Scope of the revision

29th Floor - M-529 SD R2: Bubbled Areas

30th Floor - M-530 SD R2: Scope and Quantities

31st Floor - M-531 SD R2: Scope and Quantities

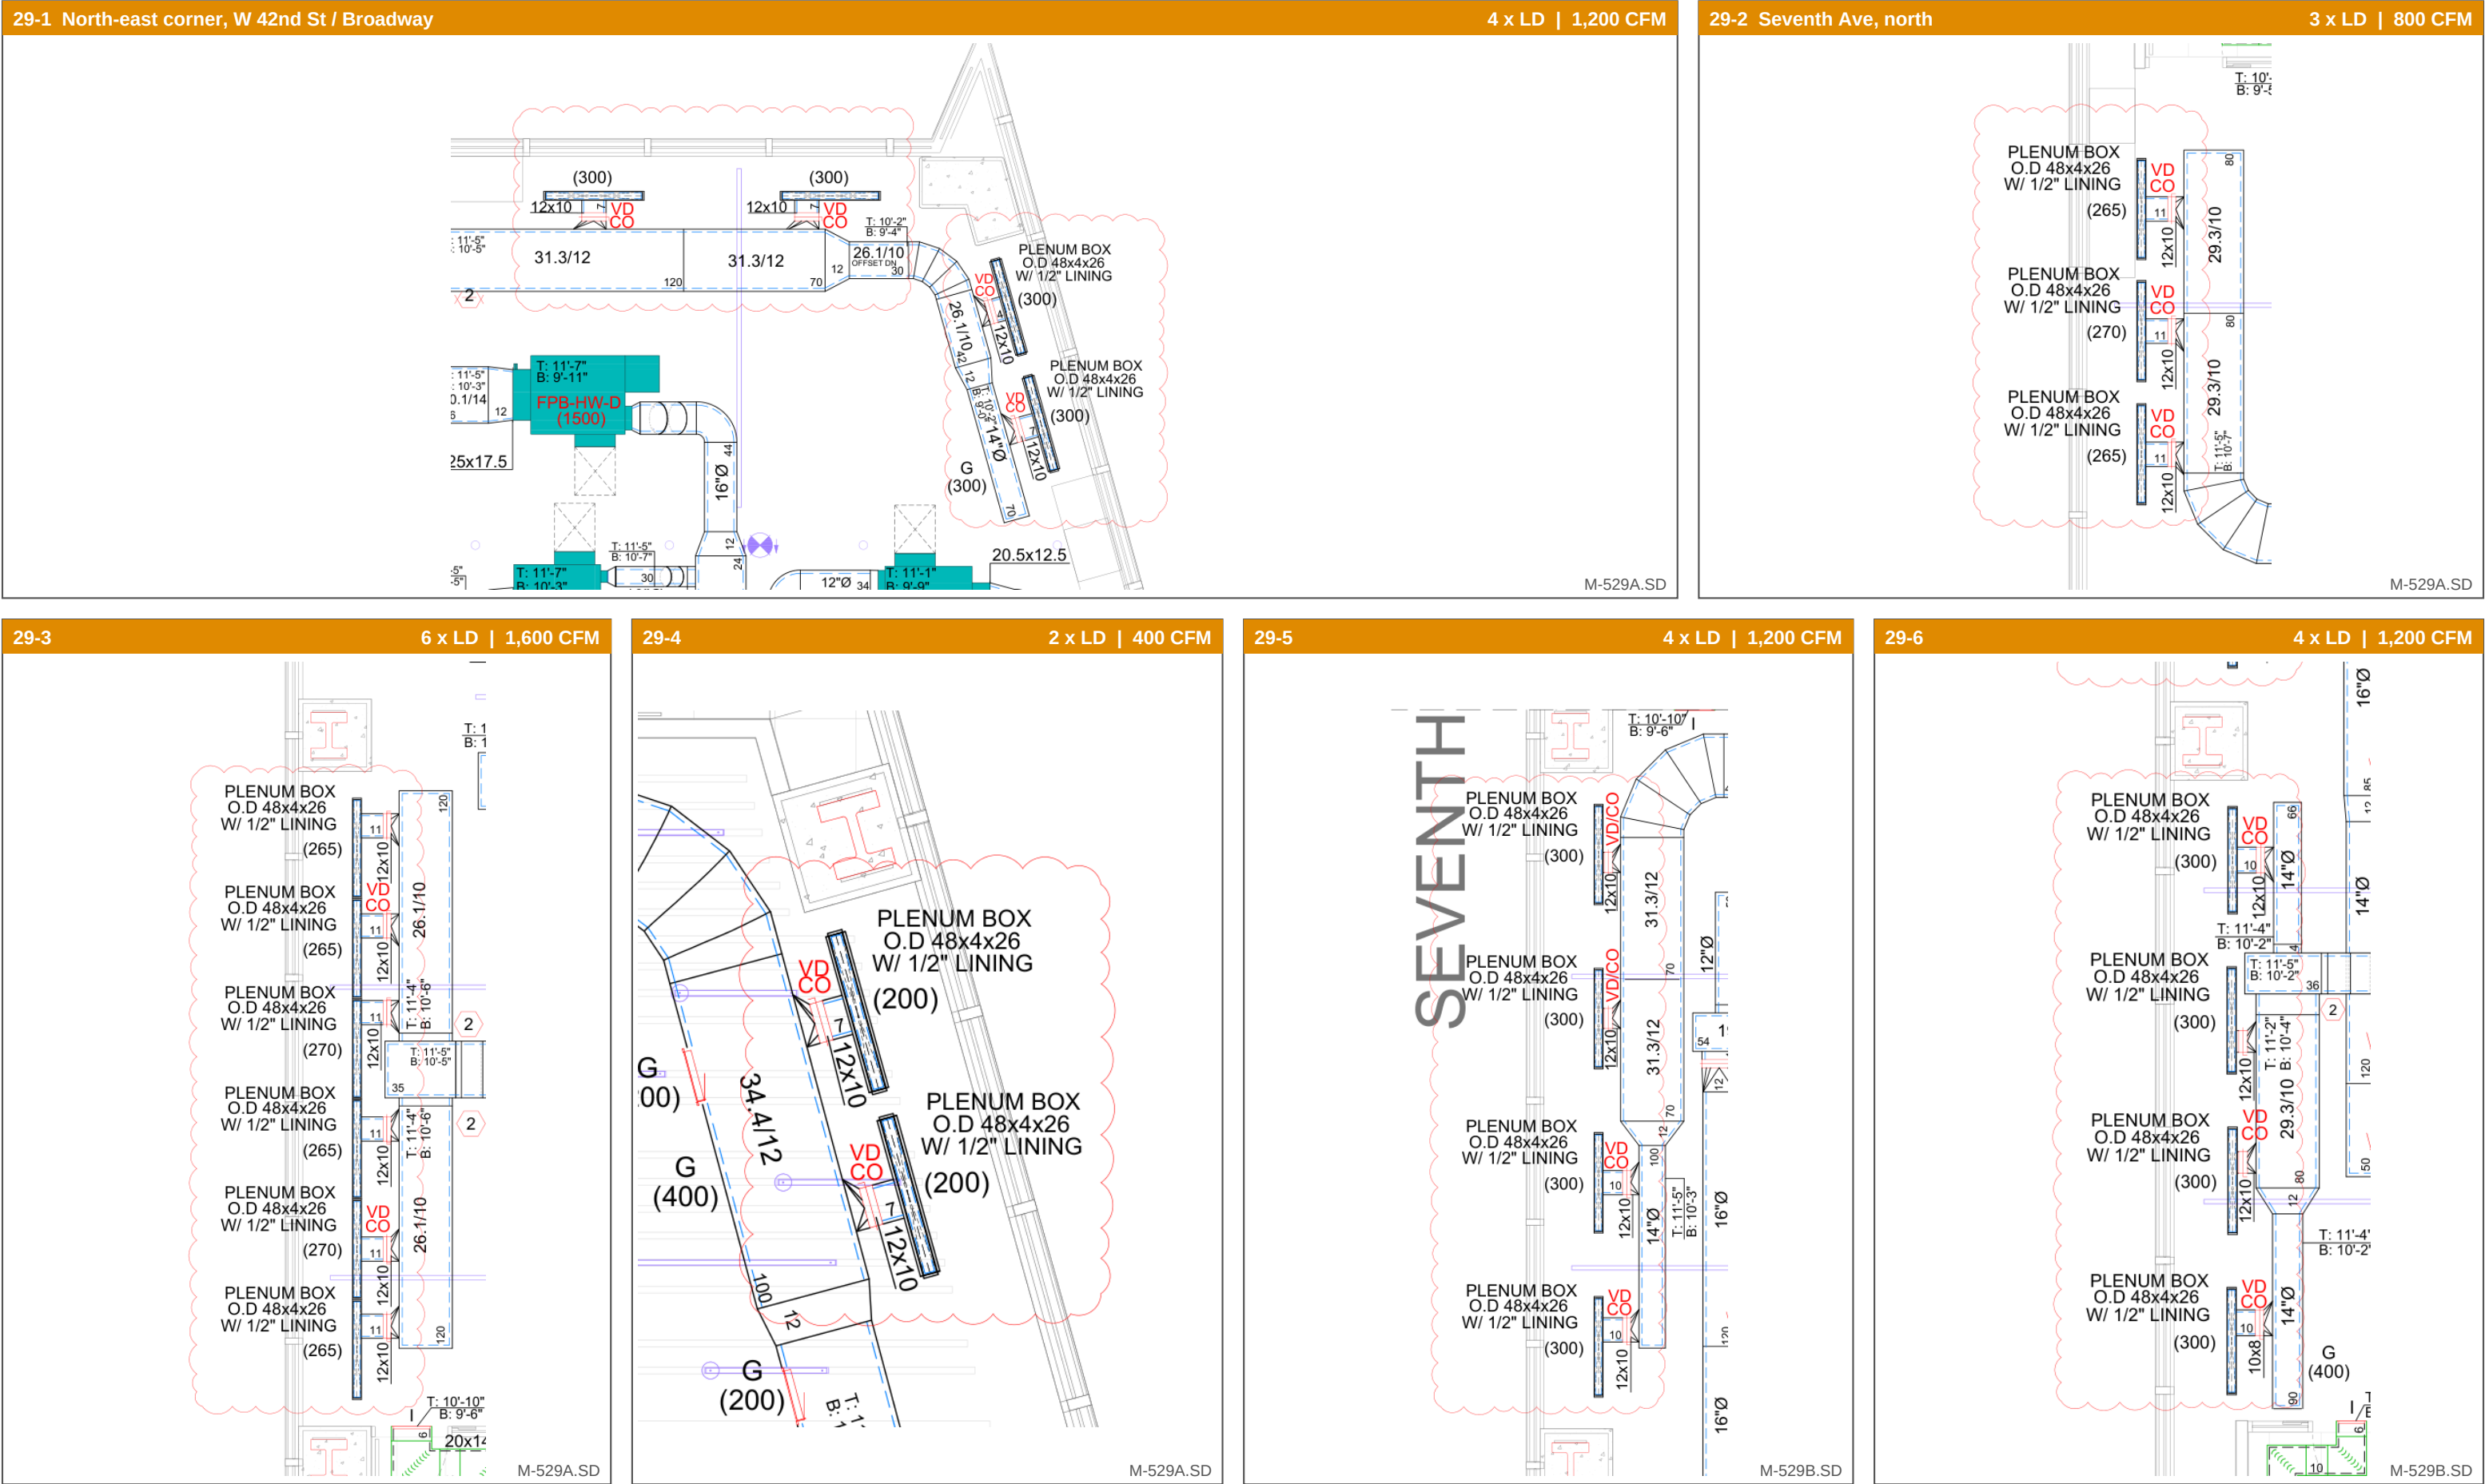
23 perimeter linear diffusers in plenum boxes O.D. 48x4x26 w/ 1/2" lining, 6,400 CFM | quantities on next page

31-1 Seventh Ave, north (Focus Rm 31.65 / Corridor 31.51)

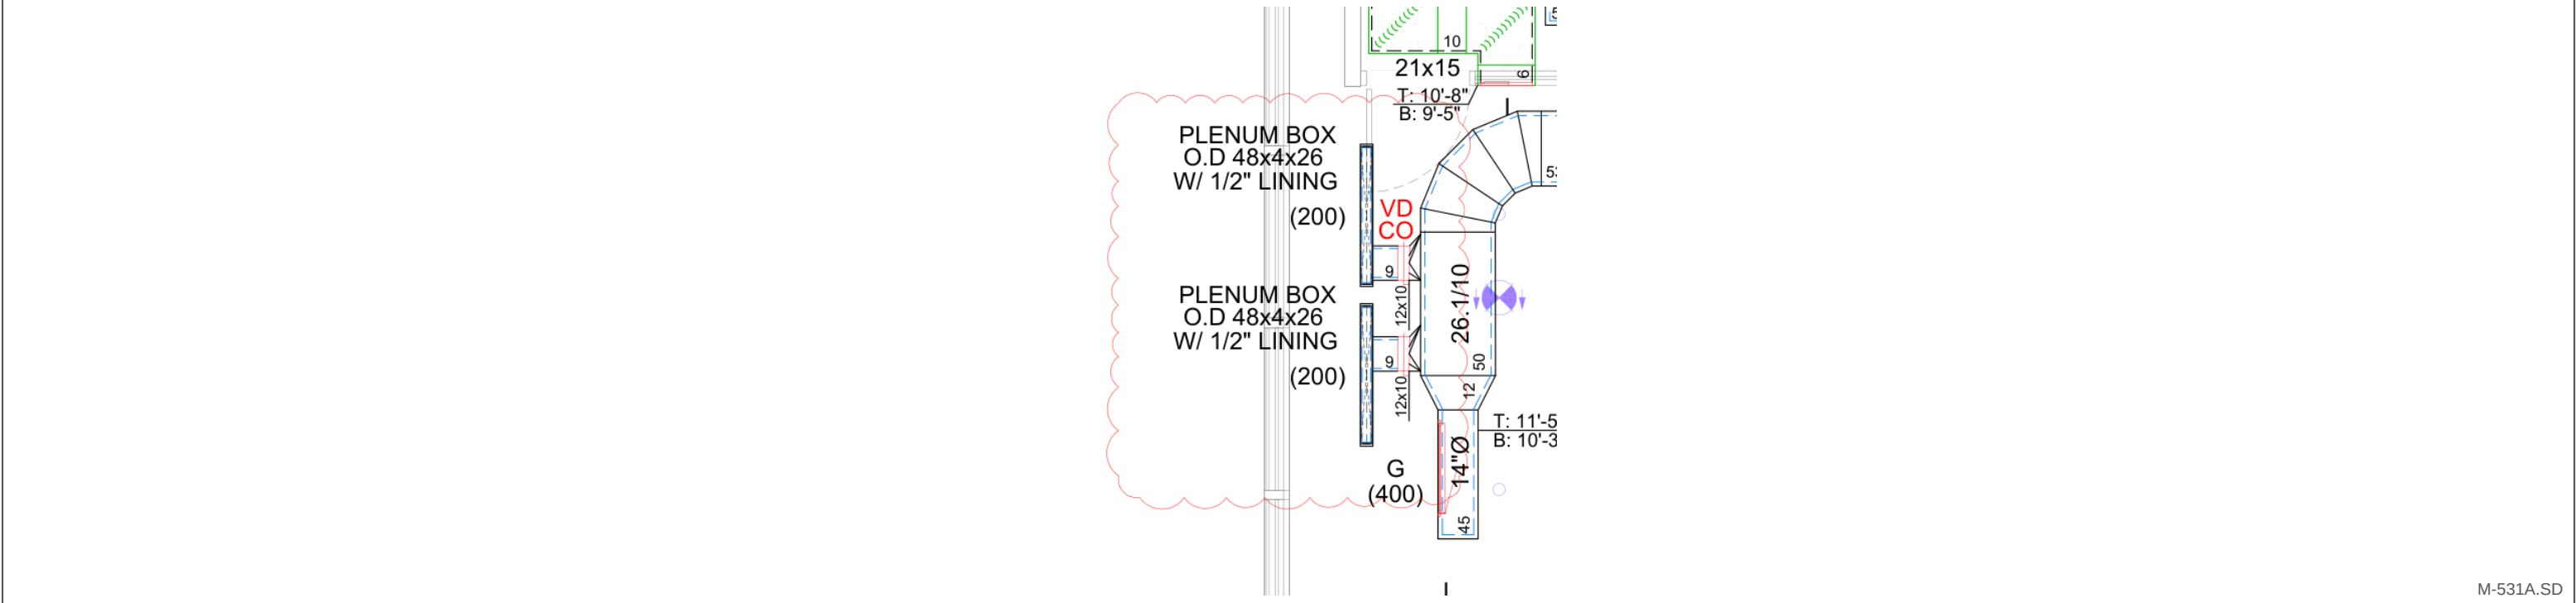
2 x LD | 400 CFM

31-2

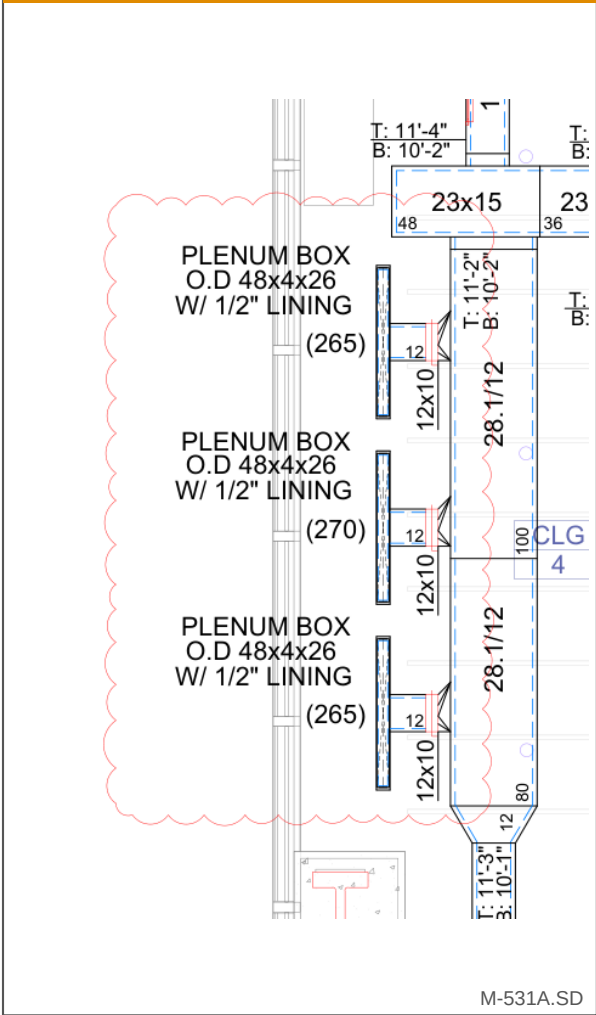
3 x LD | 800 CFM

31-3

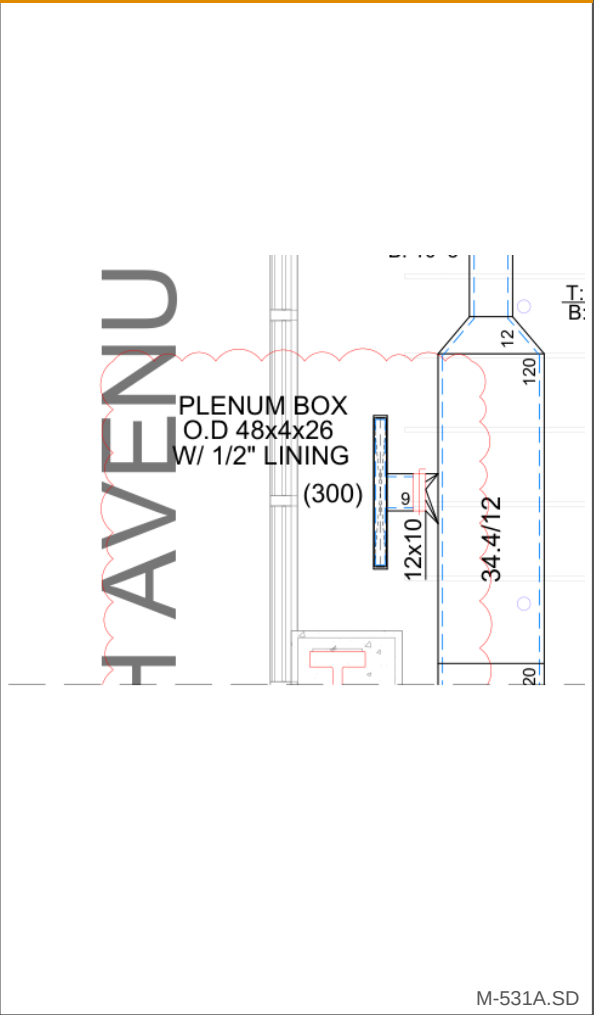
1 x LD | 300 CFM

31-4

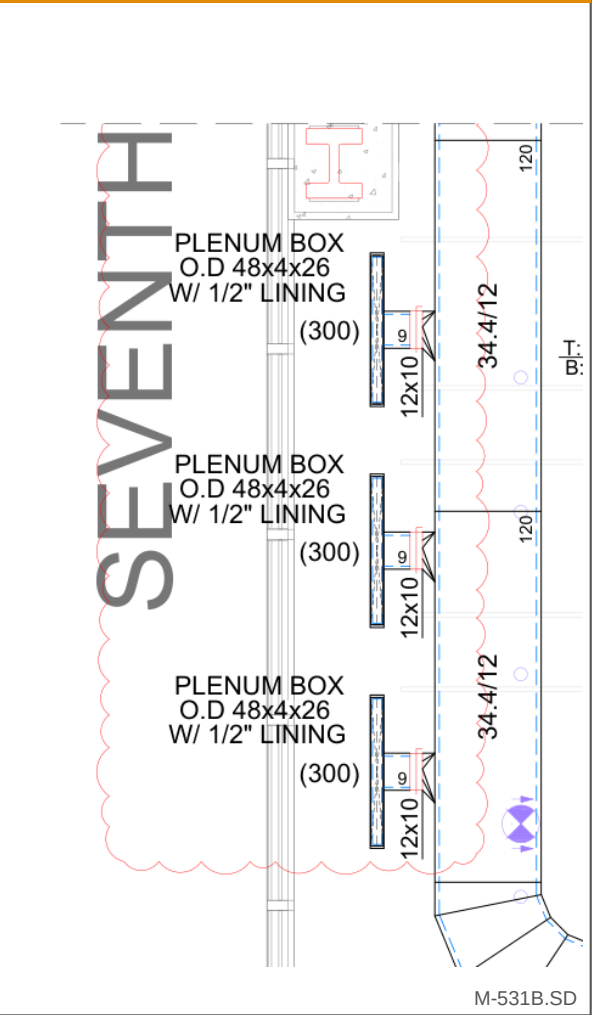
3 x LD | 900 CFM

31-5

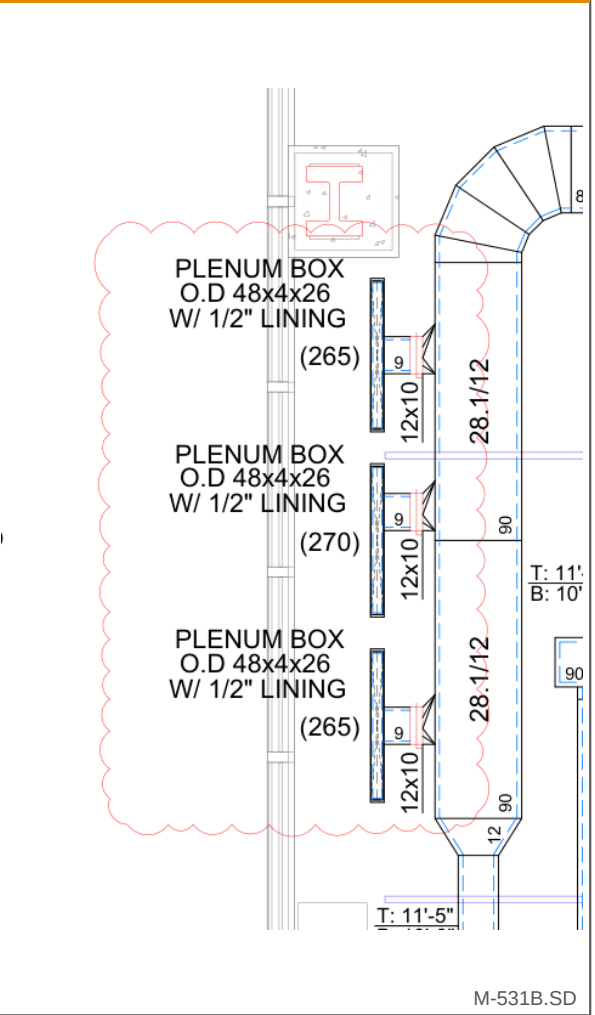
3 x LD | 800 CFM

31-6

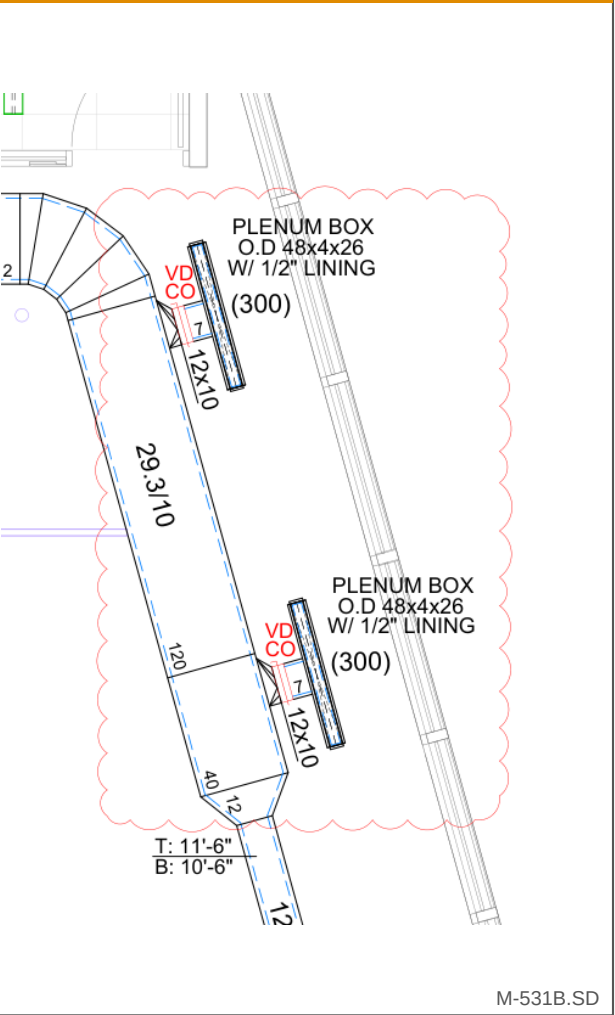
2 x LD | 600 CFM
